419 71ST STREET
DPD #3017353

GREEN LAKE MIXED-USE

2ND EARLY DESIGN GUIDANCE MEETING

OCTOBER 27, 2014

MAIN LEVEL - OPTION E FROM AUGUST 18 EDG

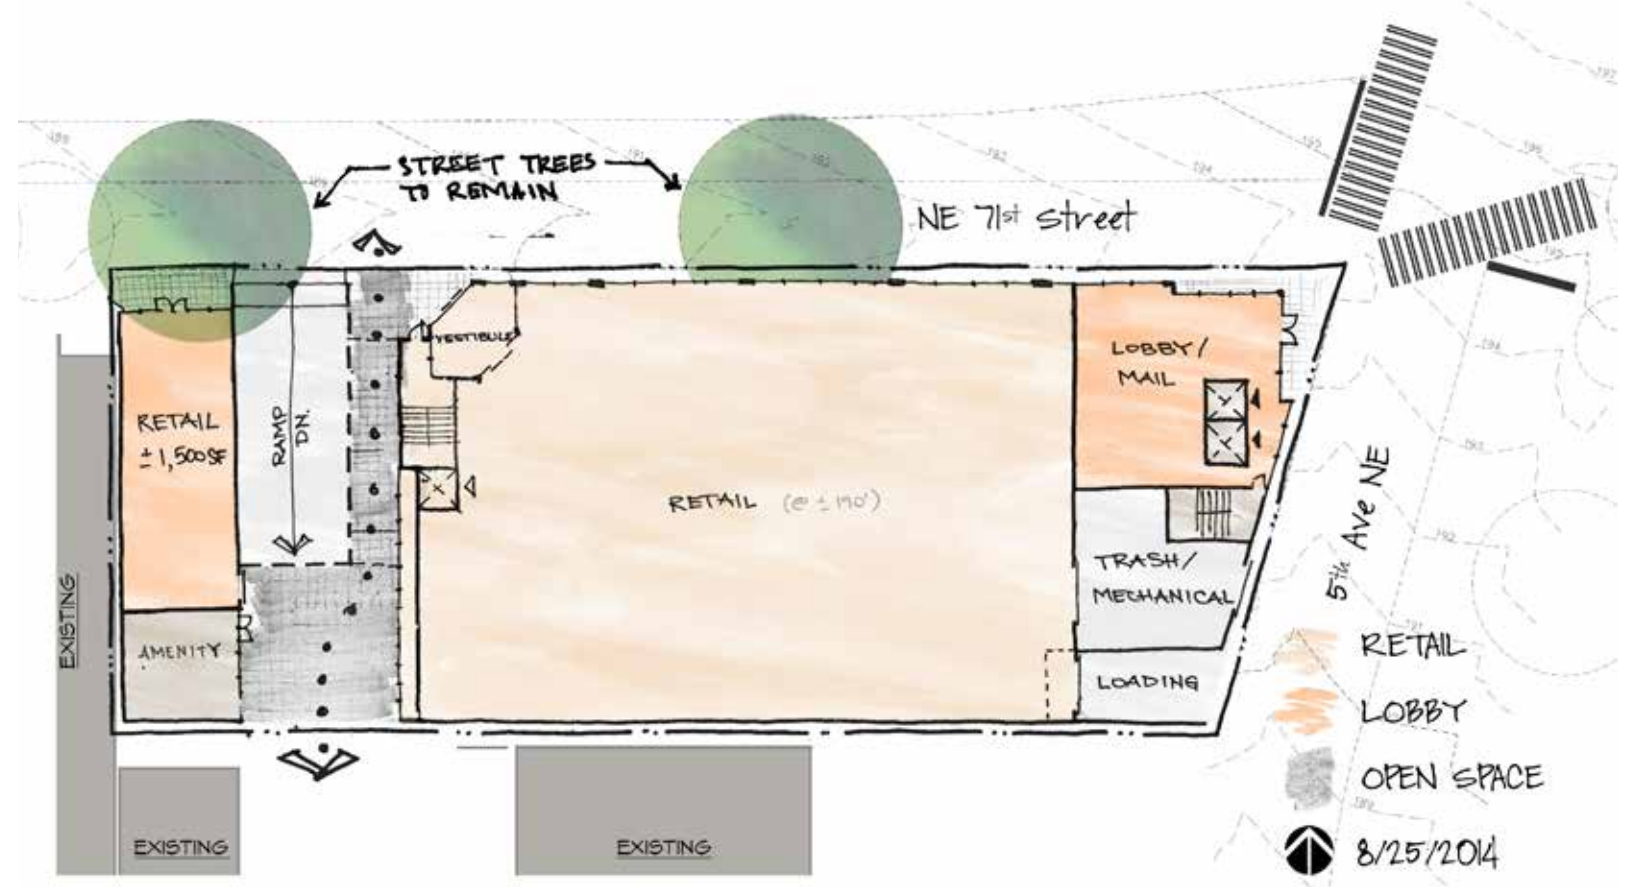
During the August 18, 2014 EDG, the Board provided the following specific comments on Applicant's initial efforts to show such connection:

Through Block Connection and Upper Level Massing. The Property is subject to a Property Use and Development Agreement (PUDA) as a condition of the approved 2005 rezone. The PUDA requires the applicant to make a good faith effort to design a mid-block, through-block pedestrian crossing, recognizing that the existing ownership pattern on the South Parcel may make this infeasible. The Board was particularly concerned with the lack of design options providing a viable through block connection from NE 71st Street to NE 70th Street. The Board noted that Vitamilk South LLC owns an adjacent parcel south of the subject lot that would allow a viable through block connection. The Board felt additional site design and upper level massing studies were necessary to demonstrate the required good faith effort required by the PUDA. The Board noted that a substantial number of people cut through site from Oswego Place NE to the new midblock connection and PCC located north of the subject lot. The Board agreed a connection at this location would be extremely useful because of the substantial grade change on the adjacent streets and because 5th Avenue NE is not a pedestrian friendly street. . . .

The Board felt that the Option E ground plane design was the most successful case study for including a through block connection. The Board requested additional ground plane design with variations of Option E (CS2-B, CS2-li, CS2ii, PL-A1, PL-B, PL2-B, DC1-A, DC2-A, DC3-A). . . .

The Board directed that the commercial use should front and include the predominant transparency and entrances along NE 71st Street and the through block connector to help activate the through block space (PL3-C, DC1-B2).

For reference, the sketch provided in the August 18 EDG package for “Option E” is provided on this page. The Board will recall that a variety of options were provided, but Option E was the version in which the Board was most interested. The following constraints preclude Option E, at least as it was shown in the August 18 packet:

- SDOT remains adamant about preservation of both existing trees along the site’s northern edge, and tree preservation continues to be a primary design consideration.

- A Letter of Intent has been signed with Bartell Drugstore—a desirable and missing amenity in the neighborhood— and we need to maintain the retail space at dimensions in order to meet Bartell’s requirements while keeping the overall layout flexible to allow subdivision into small shops in future.

- The western street tree and the need to locate the garage portal away from the intersection forces the portal to the location in which it is shown.
- The loading dock is located in the only feasible location given the grades, retail design and proximity to the intersection.

- The southern terminus of the crossing needs to be in a location that allows for flexibility in the future development of the small lot to the south of the site.

After the first EDG meeting the proponents studied a through-block crossing adjacent to the large retail space and a second small retail space on the west edge. It was concluded that this second small retail space was not viable due to access, parking, loading and location problems.

MAIN LEVEL - RESIDENTIAL ENTRY SHIFT STUDY

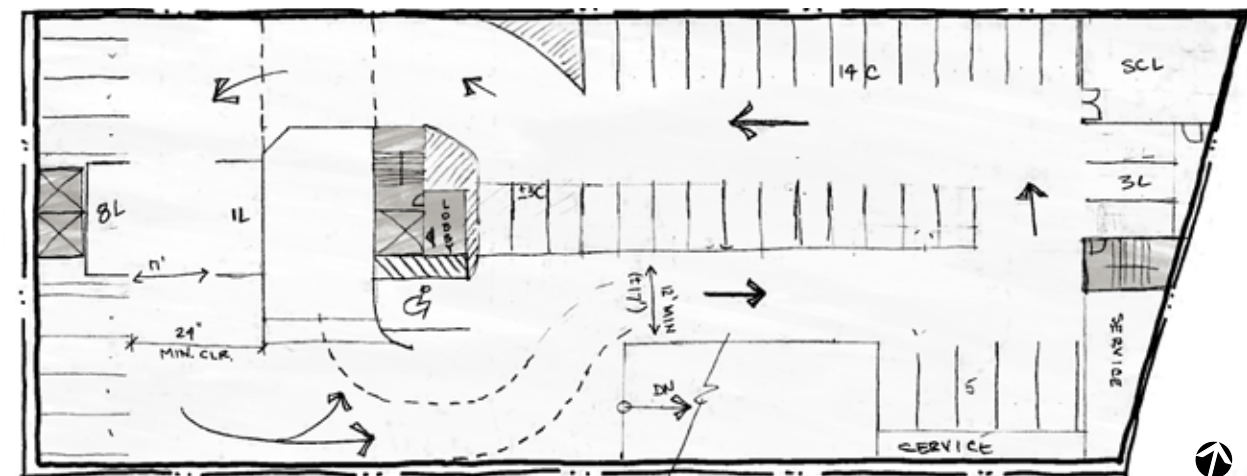
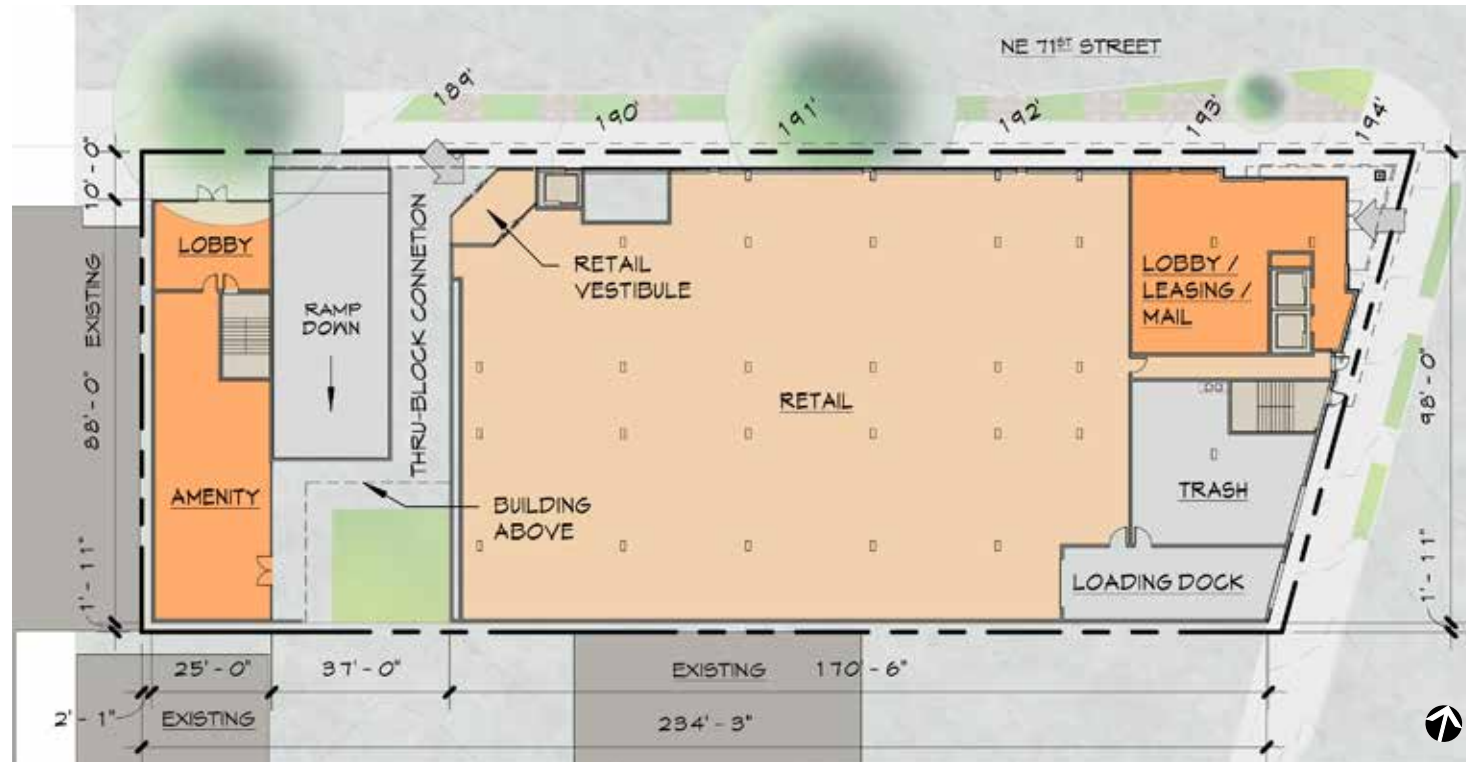
During the August 18, 2014 EDG, the Board provided the following specific comments on Applicant's residential entry locations:

ii) The Board agreed that revised ground plane design should investigate locating the residential entry at the street corner and at the most westerly portion of the façade with more direct access to Green Lake (CS2-B, CS2-ii, CS2ii, PL-A1, PL-B, PL2-B, DC1-A, DC2-A, DC3-A).

Per the Board's recommendation, we further explored the possibility of relocating the main residential entry from the street corner to the westerly-most portion of the façade with the goal of providing more direct access to Green Lake (for the reference, the previous preferred option with residential entry at NE provided in the August 18 EDG packet is shown above). After further consideration we have concluded it does not work to put the full lobby on the west side (upper right). The challenges of providing elevator access to the garage and residential floors above make siting the lobby at this location infeasible.

Specifically, site constraints such as topography and tree retention, as well as the desired retail space for future tenants require that the garage entry be located on the west end of the site, as shown in the massing design options. Locating the main residential lobby at far the west end of the site would isolate a part of the commercial parking level floor and force retail customers to cross two lanes of traffic at a blind corner at the bottom of the ramp (as shown on the parking plan to the right), which raises additional safety and usability questions.

PREFERRED MASSING DESIGN OPTION C - TRUCK LOADING ARRANGEMENT

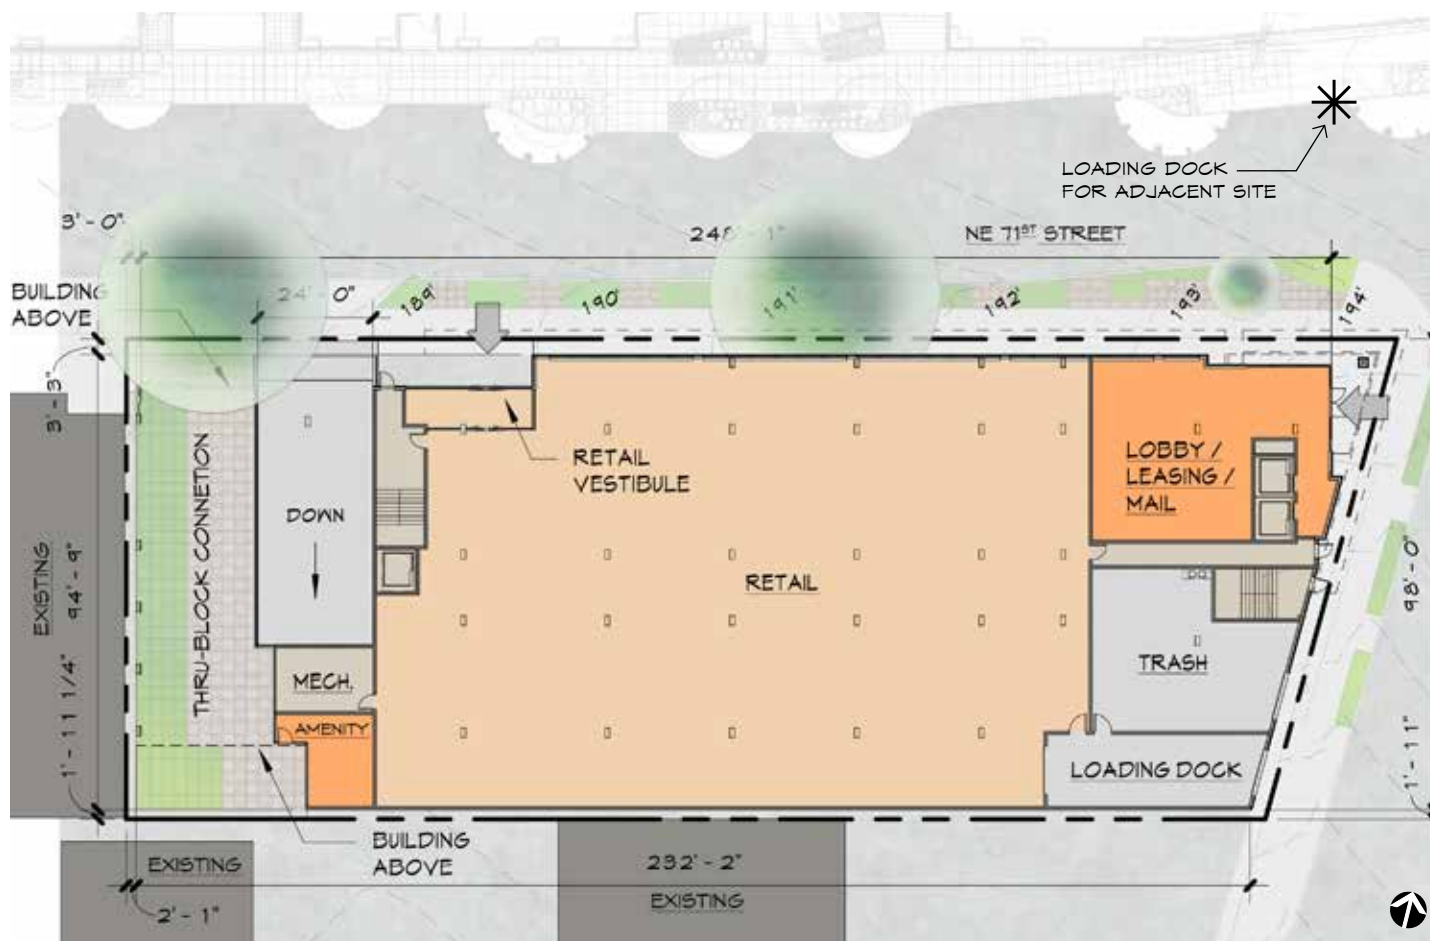
During the August 18, 2014 EDG, the Board provided the following specific comments on Applicant's loading dock locations:

The Board directed the location for truck loading and venting should be carefully considered. The Board noted Green Lake Village as a successful case study of the truck and service entry and functioning. (CS2-D5, DC1-B and C).

We studied two alternate locations for the truck loading dock. As previously stated, we do not consider these to be feasible. Our preferred alternative remains at the southwest corner of the building.

Overall, locating the loading dock on a more pedestrian-oriented street is perceived as weak, if not poor design. Therefore, we believe the proposed loading dock location on 5th Avenue NE is the best location, will have the least adverse impacts on the neighborhood, and is therefore used on all proposed ground-level plans.

- Contained within the building;
- Vents to right-of-way without negative impacts to adjacent sites;
- Best location onsite relative to potential retail user;
- No impacts to residential lobby and retail pedestrian oriented frontage.

MASSING DESIGN OPTION A (Response to i and iii)

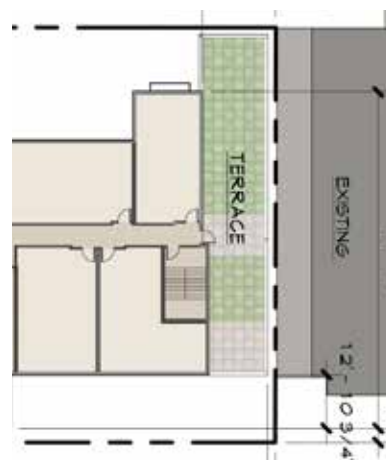
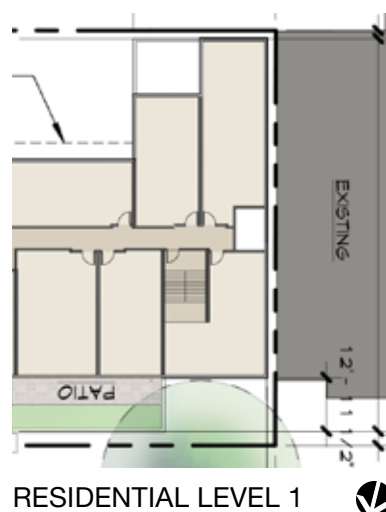
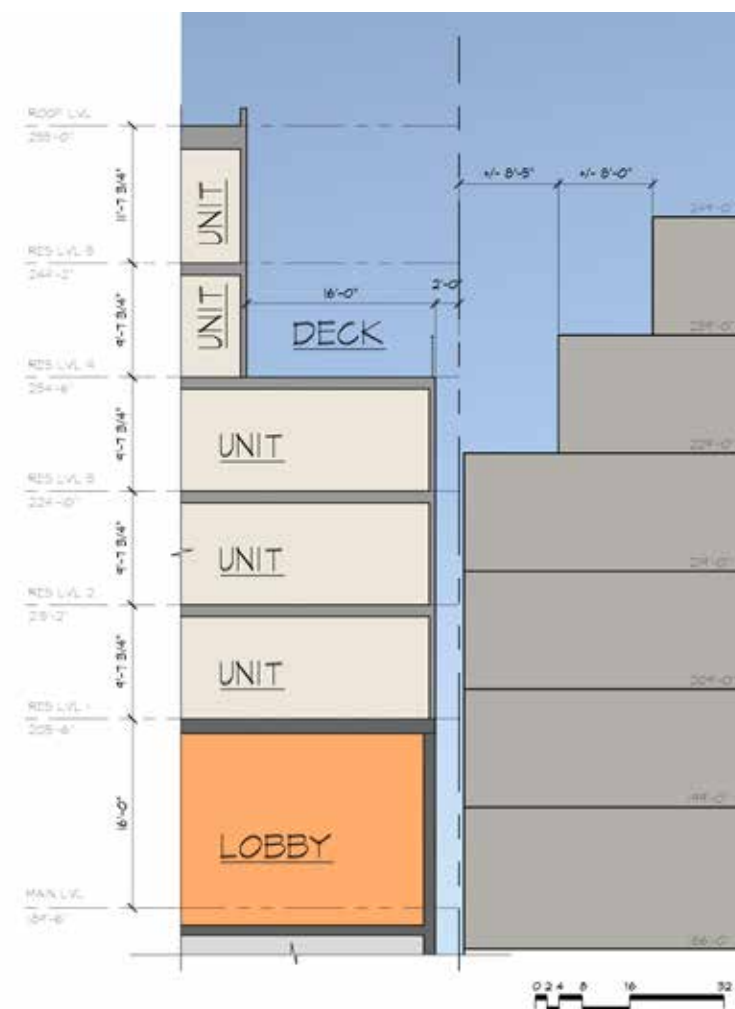
During the August 18, 2014 EDG, the Board provided the following specific comments on Applicant's upper-level massing:

- i) A separation in the upper level massing at the location of the ground level through block connection (CS2-B, CS2-ii, CS2ii, PL-A1, PL-B, PL2-B, DC1-A, DC2-A, DC3-A).

- iii) A massing which locates the primary mass of the structure adjacent to the blank wall to the west, and then provides an upper setback similar to the existing condominium building to the west should be provided for the Board to review. (CS2-C, CS2-D).

Two approaches were taken to address residential massing at the location of the mid-block connector. While a split core or bridge idea was discussed at the EDG, the application of such an idea is financially infeasible for a building of this size and infeasible for the vertical circulation elements. The analysis is similar to the analysis of through-block connection of the residential lobby on the west side shown on page 10. Therefore the split core is not shown.

Massing Design Option A separates the upper level massing by providing a major break at the through-block connection. To achieve the separation of massing, we rotated a unit on the south side and created more compact units on the north side. At the expense of five lost units, this Massing Design Option provides more natural light at the connection. This major break or step of the massing provides the requested separation and is still in keeping with our overall architectural concept of the mass eroding as it moves to the lake.

Massing Design Option A shows a setback away from the west property line that is more dramatic two stories high. (See Massing Design Option A Section, bottom right). As shown on the illustration, the two upper levels are set about 18 feet away from the property line, as opposed to approximately 8 and 16 feet respectively on levels 4 and 5 of the adjacent Green Lake Condominium building.

MASSING DESIGN OPTIONS B AND C SECTION AT WEST PROPERTY LINE

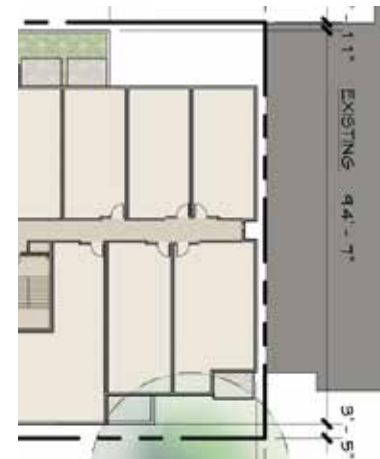
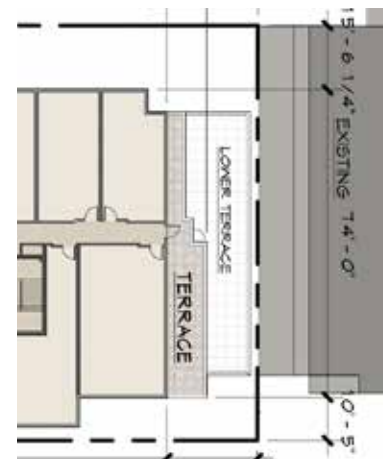
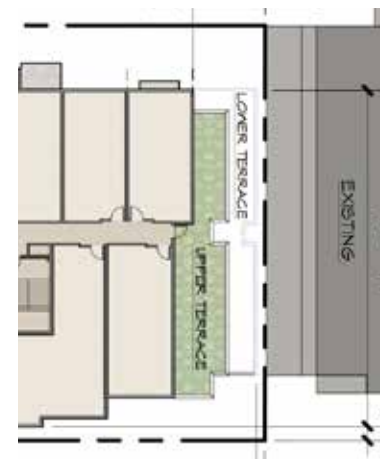
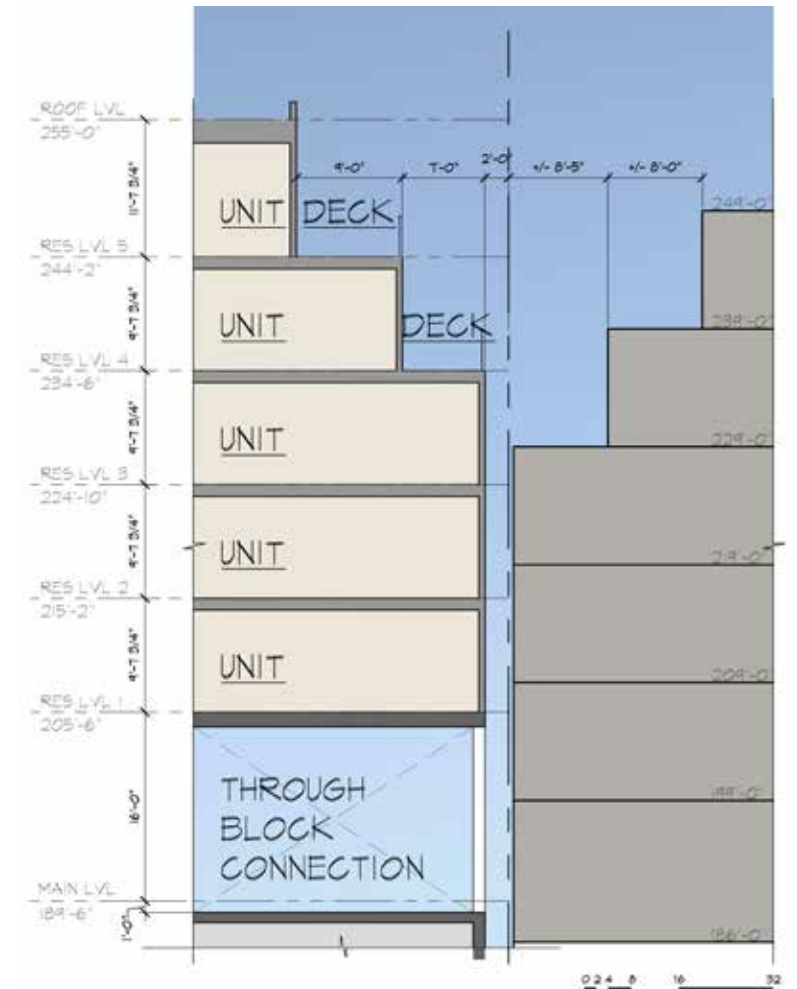
During the August 18, 2014 EDG, the Board provided the following specific comments on Applicant's upper-level massing:

ii) A continuous upper level massing that locates residential units above the through block connection. The Board directed the applicant to review Alley 24 and the Stack House projects in South Lake Union as successful case studies of a through block connection covered by building mass (CS2-B, CS2-li, CS2ii, PL-A1, PL-B, PL2-B, DC1-A, DC2-A, DC3-A).

iii) A massing which locates the primary mass of the structure adjacent to the blank wall to the west, and then provides an upper setback similar to the existing condominium building to the west should be provided for the Board to review. (CS2-C, CS2-D).

Massing Design Options B and C demonstrate the options with more subtle massing shift, and a more continuous residential mass covering over the mid-block connector. Consequently, these two options take advantage of the full site width to up the project's density. The architectural concept is stronger as the sense of erosion of the building mass is better suited to more subtle shifts than the larger shift. Well placed lighting could be used for these two options to enhance the through-block experience.

Design Massing Options B and C show gradual step back away from the west property line, similar to the gesture at Green Lake Condominium building (See Massing Design Option B & C Section on page 14). In these two options, residential level 4 is pulled back approximately 9 feet from the property line, and level 5 additional 9 feet, allowing better air and light flow between the two projects.

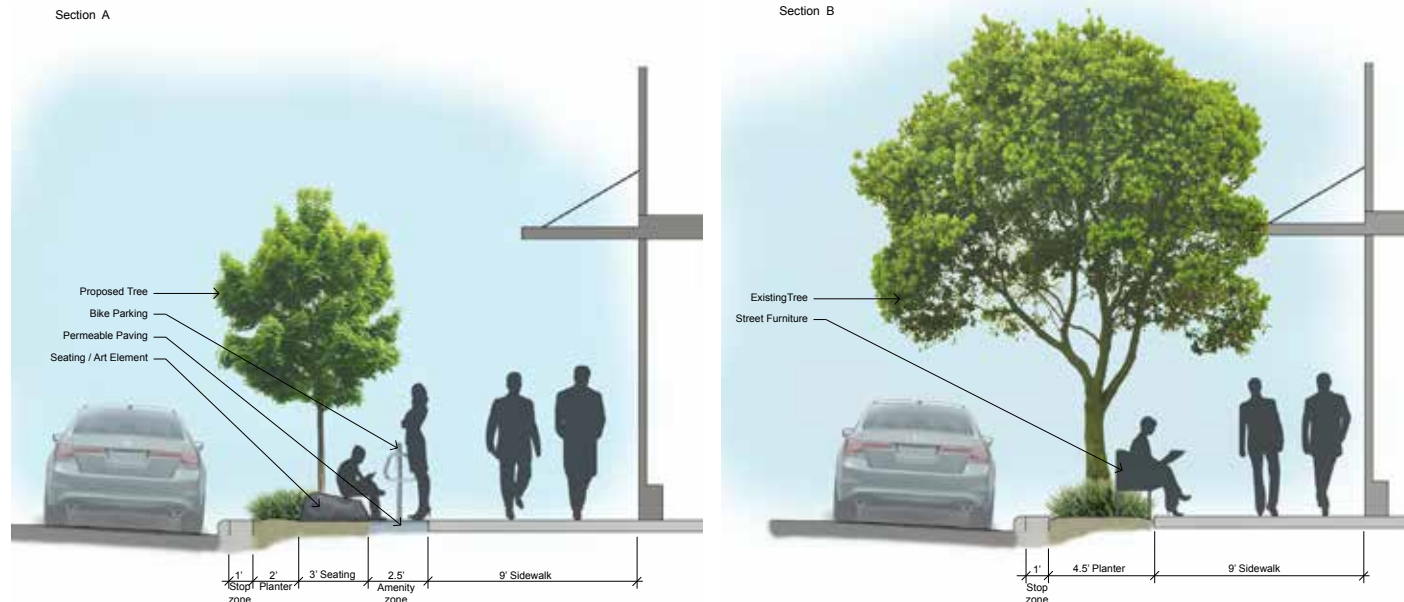
During the August 18, 2014 EDG, the Board provided the following specific comments on Applicant's ground plane open space design:

2. *Ground Plane Design.* The Board felt additional efforts were necessary to provide a pedestrian friendly ground plane and right-of-way design which incorporates additional amenity space.

a) *The Board noted that both right of-way trees are worth retaining, particularly the tree in the northwest corner of the site. The Board applauded the preferred massing alternatives response to the right-of-way tree canopy (DC4-D).*

c) *The Board directed that a truly enhanced landscape right-of-way with wider sidewalks should be provided. The Board expressed support for the inspirational images within the packet, but felt a larger amount of open space is necessary to achieve a similar result. (PL-A1 and B).*

CONCLUSION: The existing trees will be retained at the direction of SDOT Urban Forestry. SDOT Urban Forestry has requested that we look for opportunities to plant an additional tree(s) along NE 71st Street. We are proposing that additional trees be clustered at the east end of NE 71st Street in the curb bulb open space. Proposed trees will be small stature garden trees, due to the overhead power lines.

CONCLUSION: The proposed streetscape design includes 9' sidewalks, with an additional 5' of space for planting and connections through to parallel parking. The additional 3' of sidewalk space will provide for a generous circulation space, 1' safety strips at the curb in conjunction with 8' wide paved zones will protect landscape from foot traffic related to parked vehicles and will be consistent with the existing context of newer buildings in the neighborhood. An elongated curb bulb at the east end of NE 71st Street has been coordinated with the bike master plan and is pending approval from SDOT. This space allows for additional landscaping and amenity space within the streetscape while maintaining the wider sidewalk. In addition, the curb bulb shortens the pedestrian crossing zone across NE 71st Street, improves the layout of the existing intersection.
